NORTHERN VIRGINIA COMMUNITY HOSPITAL, LLC

SPECIAL EXCEPTION APPLICATION SPEX 2008-0028

RE: Responses to Referral Comments - Broadlands Regional Medical Center, SPEX 2008-0028, ZCPA 2008-0001, and ZCPA 2008-0002

SUBJECT: Response to Comments for Broadlands Regional Medical Center
Loudoun County Application Numbers SPEX 2008-0028, ZCPA 2008-0001,
and ZCPA 2008-0002

Figure 1: Locations of Background Developments

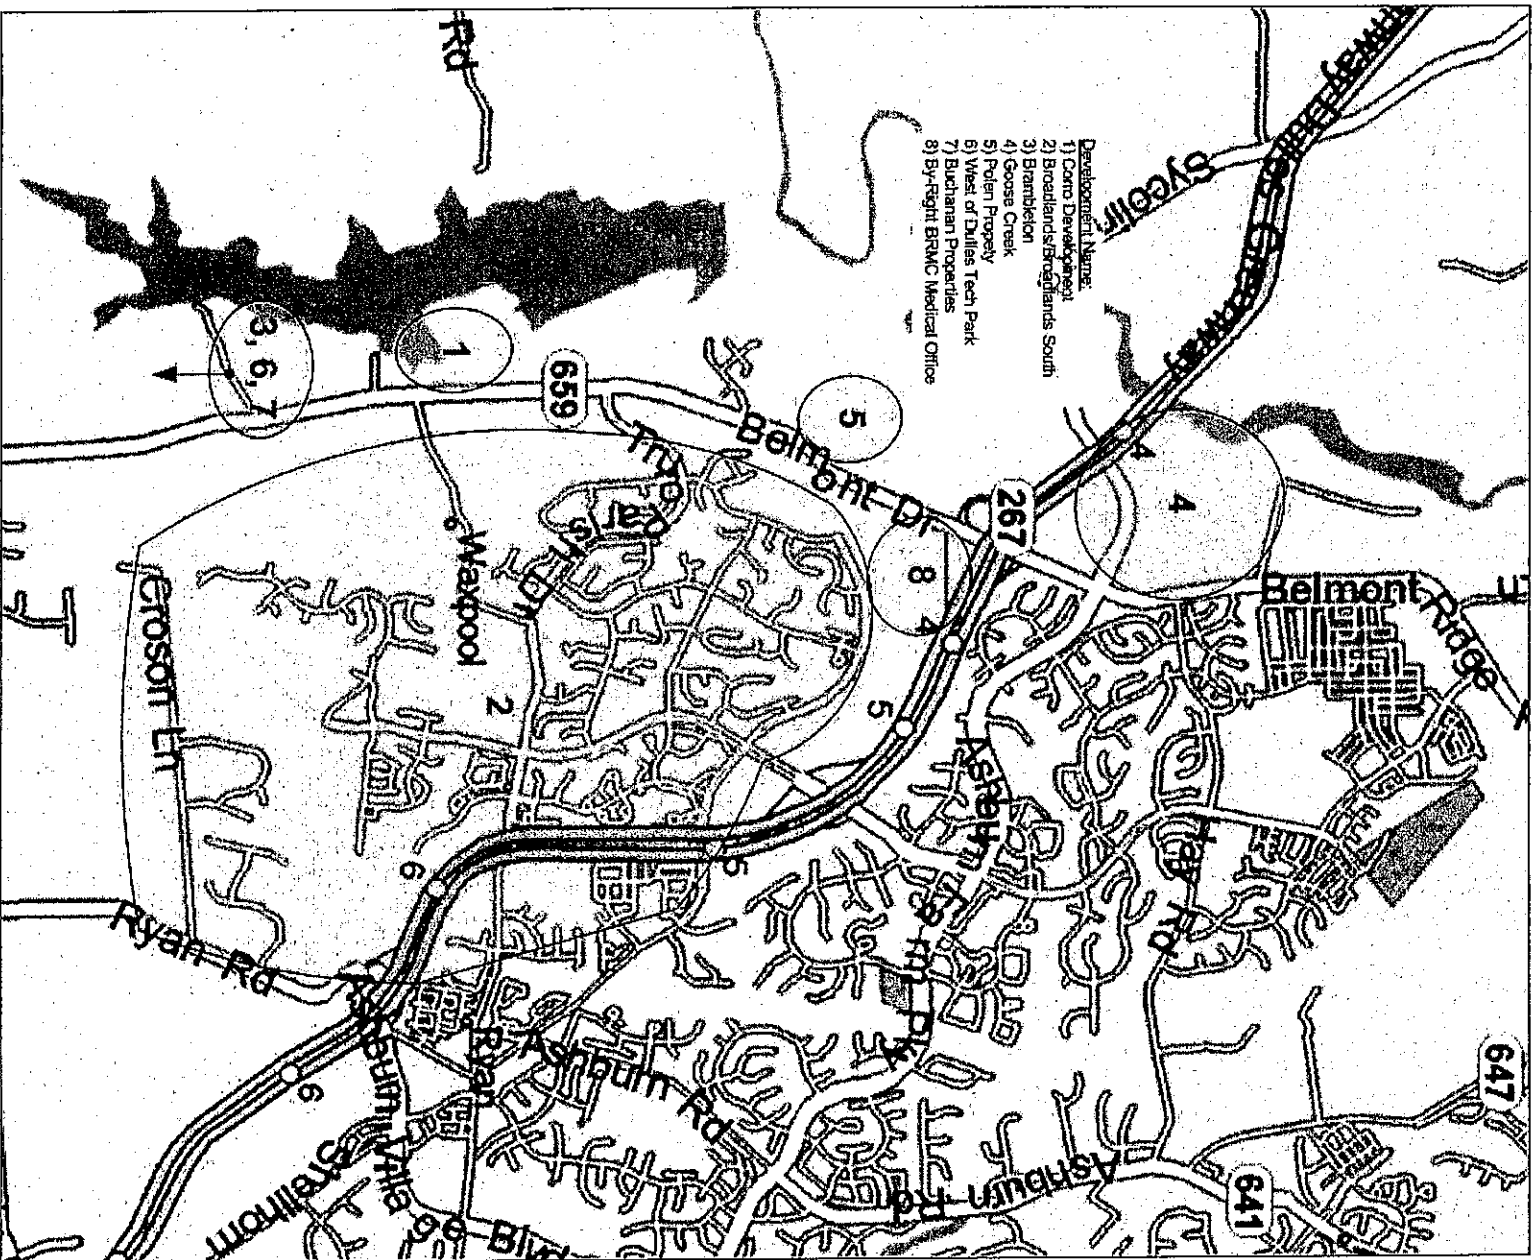
13) Provide a map showing the location of the background developments considered for this study.

A figure is attached to this memorandum showing the locations of the background developments as requested.
